Technical Service Information

ALLISON 1000/2000 SERIES

3RD OR 5TH GEAR STARTS DTC P0705, P0706, P0708

Figure 1

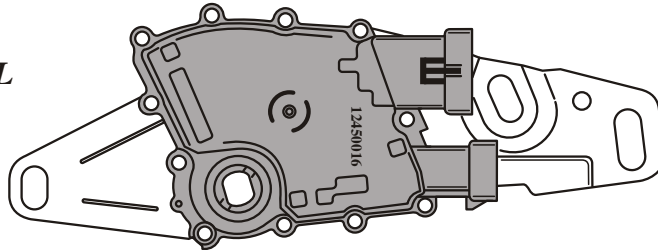
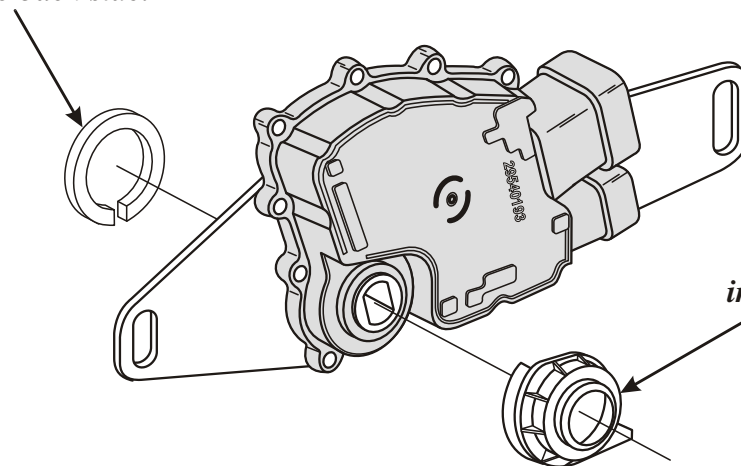
*Previous design level PNB
Switch is "Black" in color.*

*New PNB Switch has
seal glued to back side.*

*New service package
includes cover for front
side of new switch.*

*New design level PNB Switch is "Tan" in color,
and is available under OEM part number 29540479.*

CORRECTION: There is now available from OEM parts sources, a revised NSBU switch that has improved sealing capabilities to help prevent water intrusion, and is available under OEM part number 29540479. (See Figure 1) Since the original switch is the same part number as the 4L60-E switch, high ambient heat may have caused the sealing compound in the switch to melt and flow into the connectors, sealing the connectors to the switch. There is now available from OEM sources, service repair connectors for both the 7-way and the 4-way connectors under part numbers 15305887 and 15305925 (See Figure 3).

Figure 3

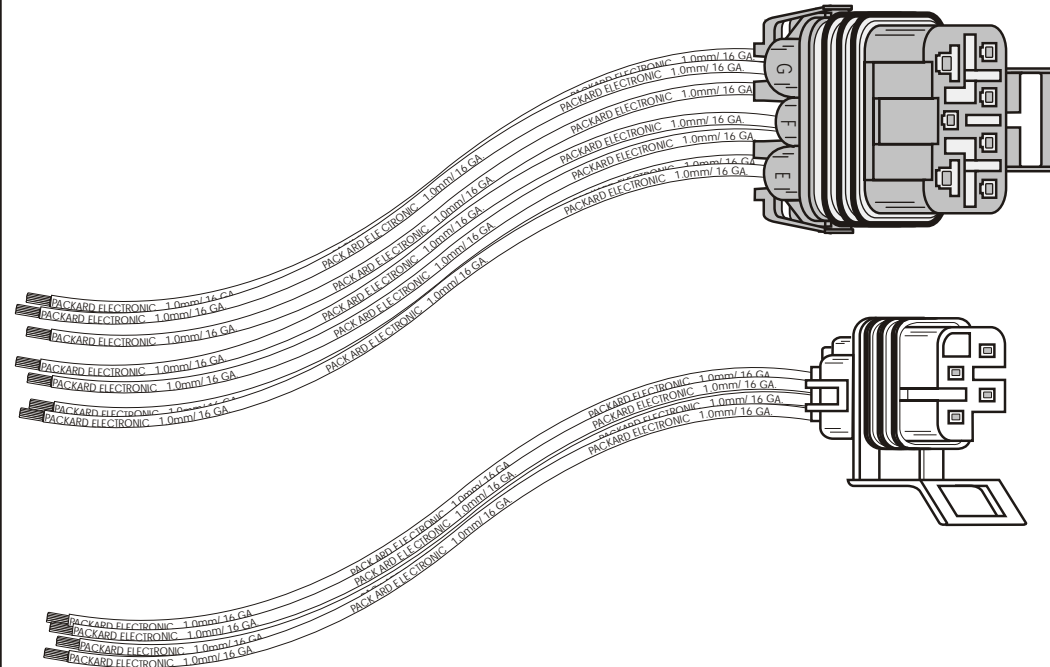
Note: The service connector pigtails use wires that are all the same color. Use the old connector as a pattern to ensure that the new wires are connected to the vehicle harness correctly. This switch is in a wet area, and it is *imperative* that the wires be soldered and heat-shrink tubing be used to insure water-tight connections. Refer to Figure 1 for the location of the Park/Neutral Position Switch. Refer to Figure 2 for a full wiring schematic of the Park/Neutral Position Switch circuit for diagnostic purposes.
